Re: 232nd Street, 132nd Ave. to Silver Valley Road conceptual design

Our Maple Ridge/Pitt Meadows HUB Committee is happy to support in principle the recommended option as shown on the display boards at the Open House on November 30, with the following suggested changes/comments:

Here is an example of cast in place curbs at Beatty Street in Vancouver:

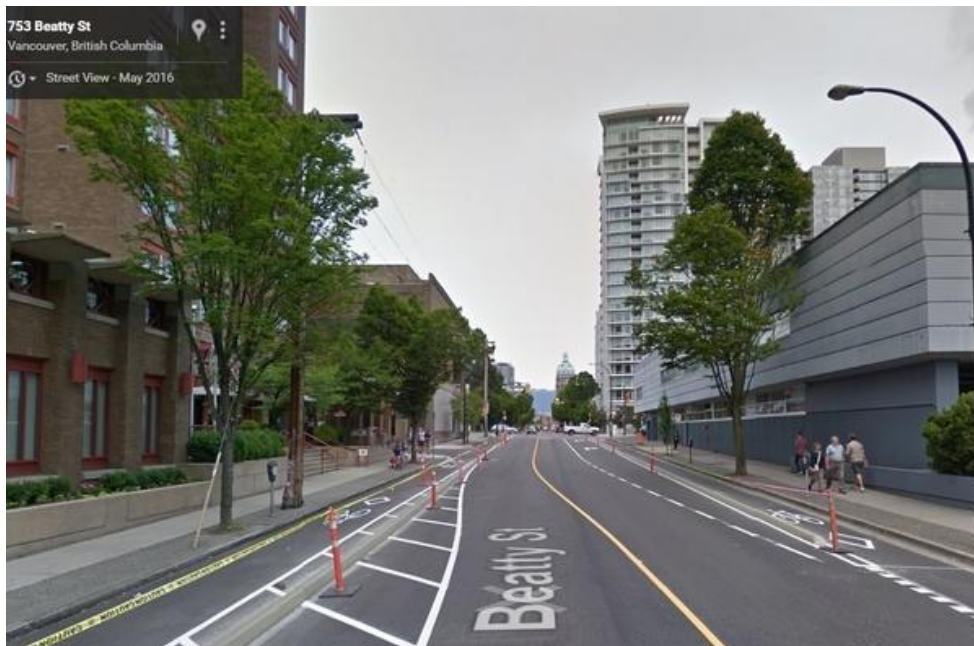
- Reduce the width of the motor vehicle lanes to 11 feet (3.35 m), as recommended in the [NACTO Urban Street Design Guide](#) for transit/truck routes. A reduction to the narrowest possible width for trucks and busses may have some positive effect on vehicle speeds on this section of 232nd Street.
- This reduction in motor vehicle lane widths means that the bike lane on the west side could be widened by 30 cm. This should improve safety when one cyclist passes another, especially at higher speeds due to the downhill nature of the bike lane.
- Our HUB committee proposes to add a cast in place curb to the bike lane on the west side, in order to prevent cars from parking on the bike lane. By placing the curb closer to the car lane than the bike lane, adequate width for safe passing can be ensured.
